Fw: Appeal of San Luis Obispo County Planning Commission Decision Certifying Final Environmental Impact Report for Loperena Minor Use Permit/Coastal Development Permit (DRC2005-00216) and Approval of Project

Re: Appeal of San Luis Obispo County Planning Commission Decision Certifying Final Environmental Impact Report for Loperena Minor Use Permit/Coastal Development Permit (DRC2005-00216) and Approval of Project

Letter from Haro, Kasunich and Associates, Inc.
"Review of Shoreline Engineering Bluff Study dated 9/28/14", dated December 2, 2014

Subject: Review of "Evaluation of Bluff Geometry Adjacent to Loperena Property"
prepared by Shoreline Engineering dated 9/28/14

FIGURE 3: 1953 TOPOGRAPHIC MAP BY SHORELINE ENGINEERING, INC. SHOWING 1953 TOP EDGE OF BLUFF AS DEPICTED ON CROSS SECTIONS BY SHORELINE ENGINEERING, INC.

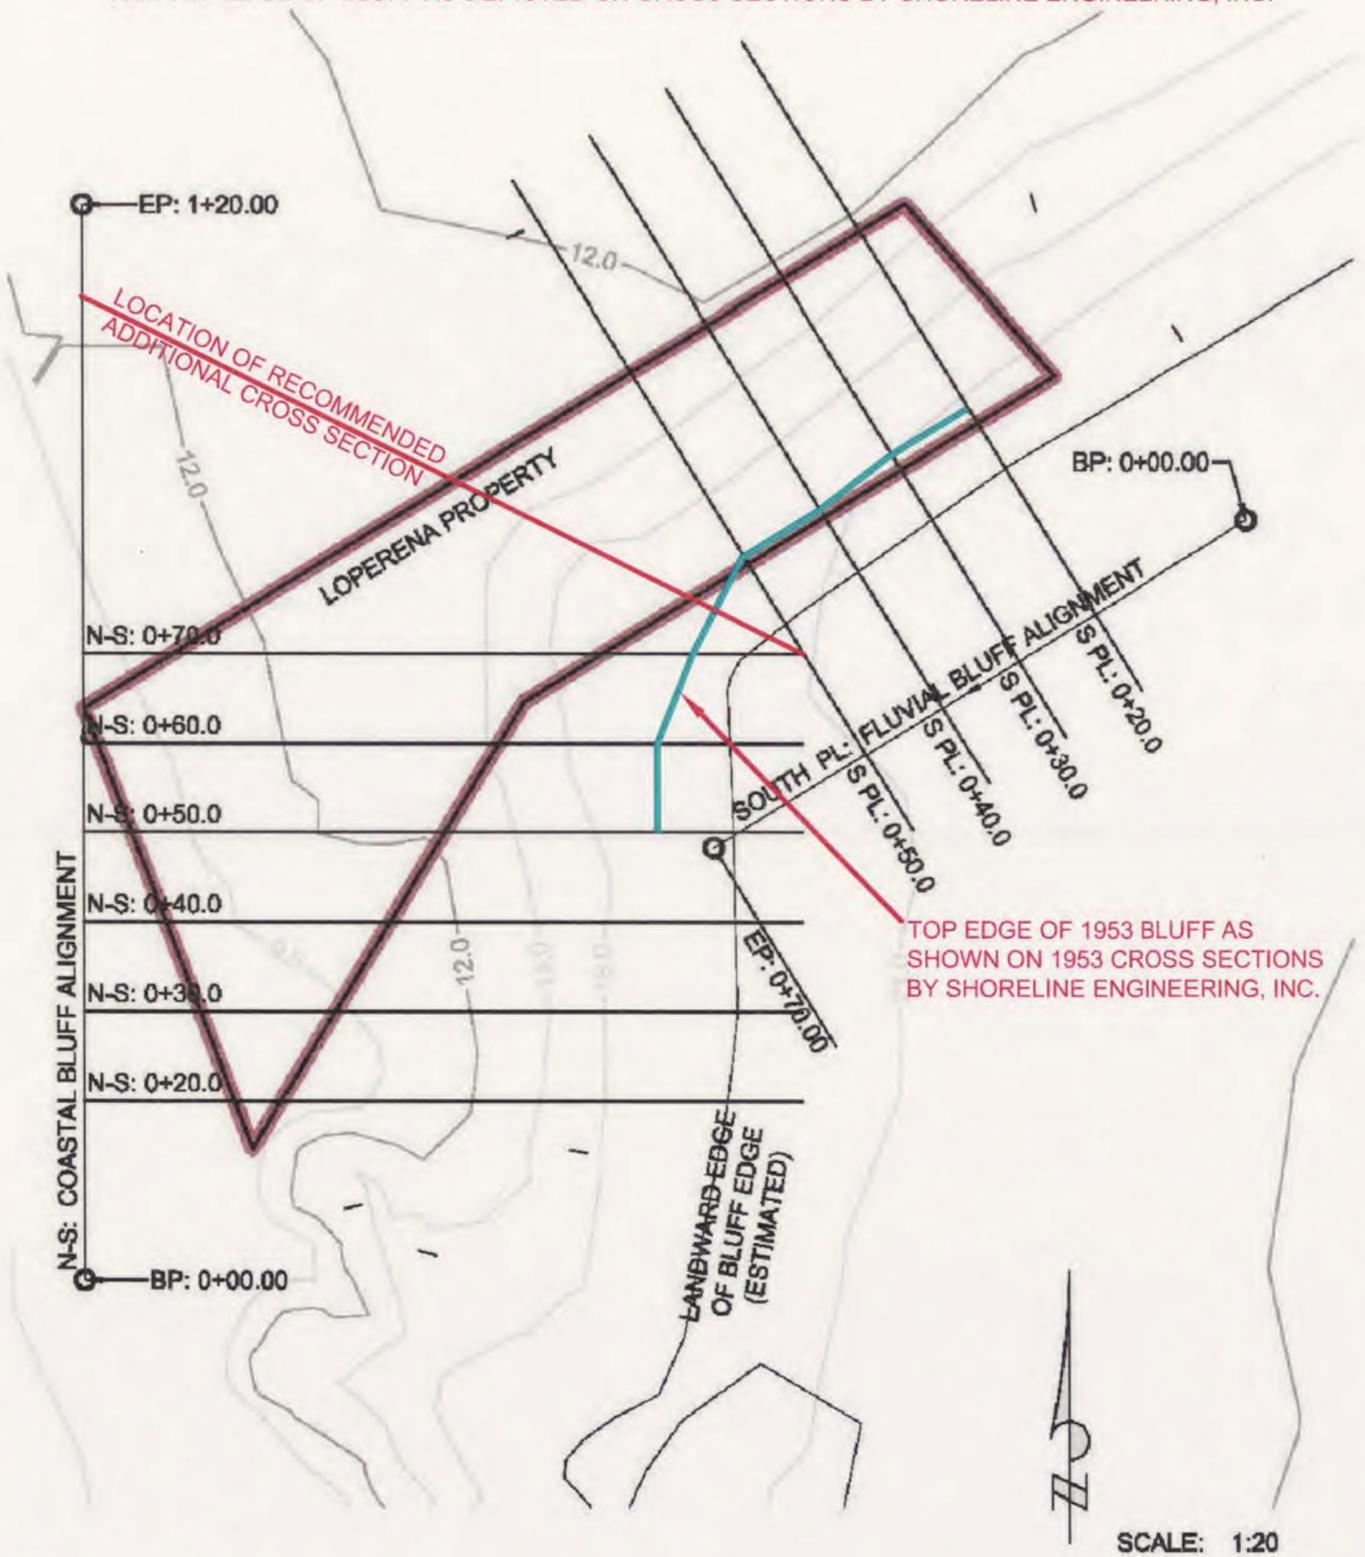
9. Based on the 1953 cross sections provided in the Shoreline Engineering study, we have mapped the top edge of the natural 1953 bluff on the 1953 and 2014 topographic maps provided Shoreline Engineering, see attached Figures 2 and 3. Most of the proposed development on the Loperena property is located below the top of the bluff and on the bluff face. SLO Coastal Plan Policies page 10-10, Policy 11 Development on Coastal Bluffs states "New development on bluff faces shall be limited to public access stairways and shoreline protection structures." Our understanding of Policy 11 is that a residential development is not allowed on the bluff face.

FIGURE 5 - 1965 CALTRANS AERIAL PHOTOGRAPH (APPROXIMATE SCALE: 1 INCH = 50 FEET)

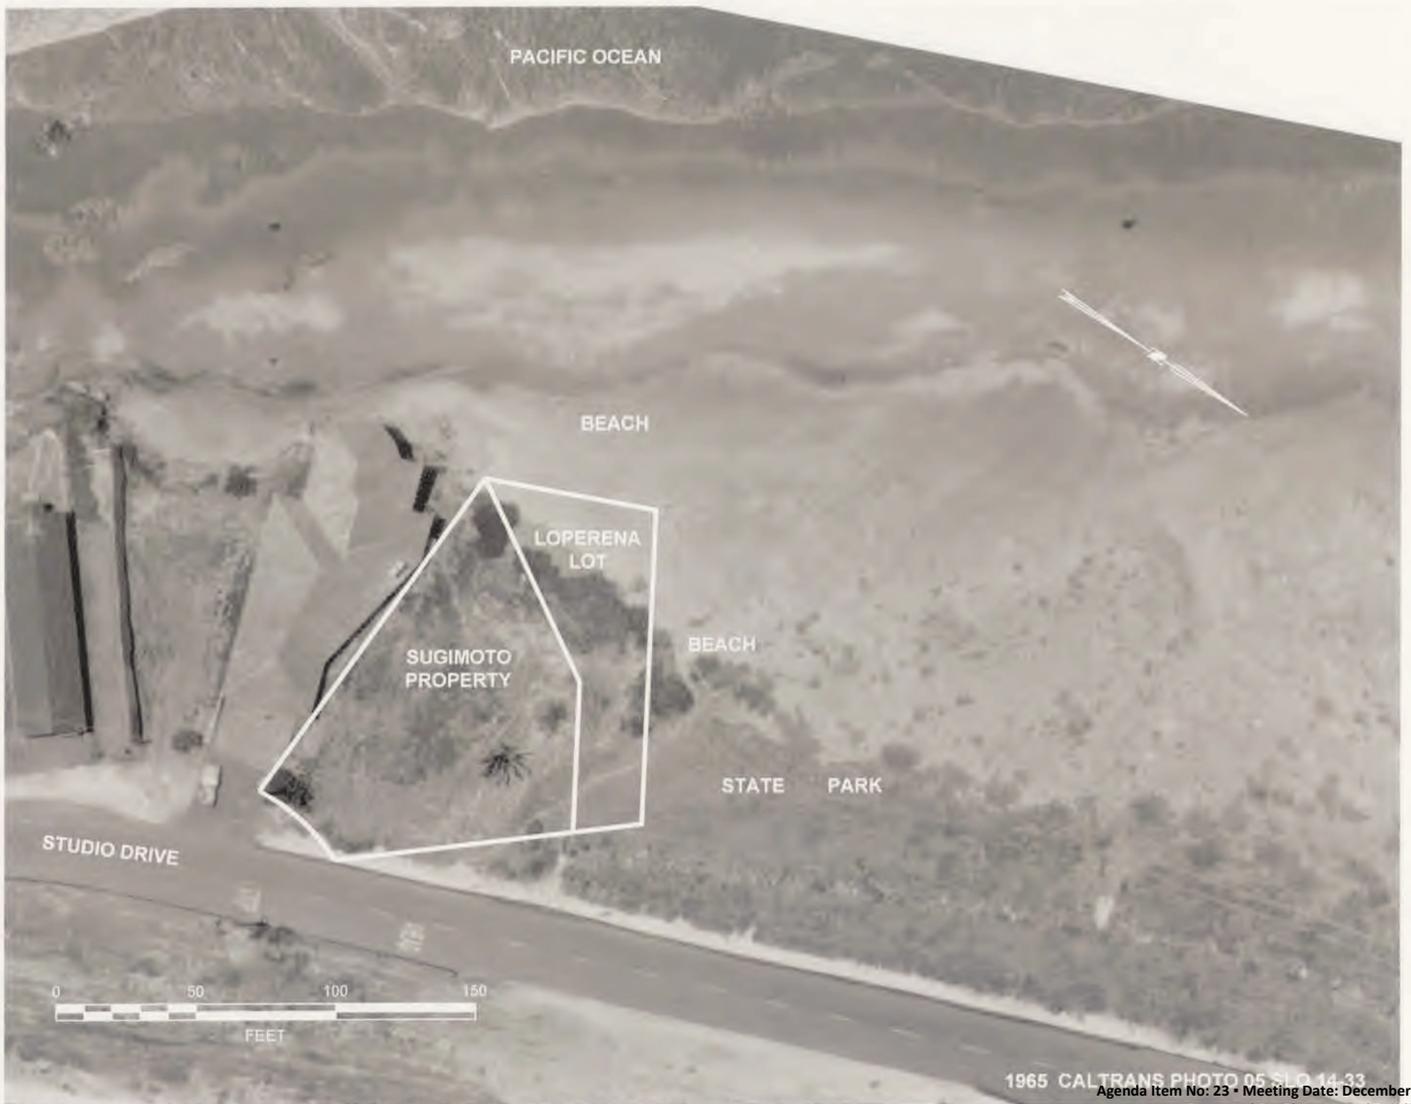
The Caltrans photographs used in the Shoreline Engineering study provide additional evidence that the toe of the bluff has historically been subject to marine erosion; and therefore this bluff is a coastal bluff. Figures 5 and 6 (attached) are the Caltrans photographs, which show evidence of recent erosion on both the Sugimoto and Loperena properties. The evidence of erosion includes areas of barren rock and areas stripped of vegetation. Evidence of ocean wave runup onto the Loperena property is visible in both Figures 5 and 6, and on Figure 8 (taken before the construction of Highway 1) and Figure 9 (taken after the construction of Highway 1 which involved placement of fill on the Loperena property). Our submittal "Review of Draft EIR Comments" dated 1 August 2013 photographically documents wave runup reaching and impacting the bluff face on the Loperena property during the last few years.
